Office Action Summary

10/696,932

MCGUCKIN ET AL.

DETAILED ACTION

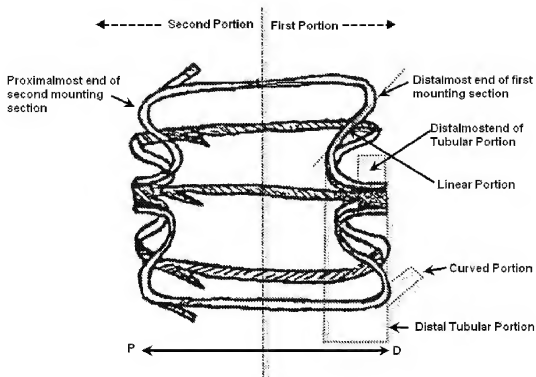
In regard to applicant's extensive claim language defining the relationship between the filter sections and mounting sections, see the Figure below depicting how the S-shape structure of van der Burg's filter section includes all the claimed components.

At least the two bottom struts on the right are shown distal of the distalmost point of the tubular section. While van der Burg does not explicitly illustrate that the ends of the tubular sections are closer to the center of the filter than the ends of the mounting sections for each strut, van der Burg does state that it is desirable to increase the contact area of the struts. One of ordinary skill in the art would be motivated to and capable of modifying the struts to increase the length of the parallel ribs, which would also cause the ends of the mounting sections to be further from the center of the filter than the ends of the tubular sections. This slight modification would also result in the ends of the tubular sections being in line with the linear portions.
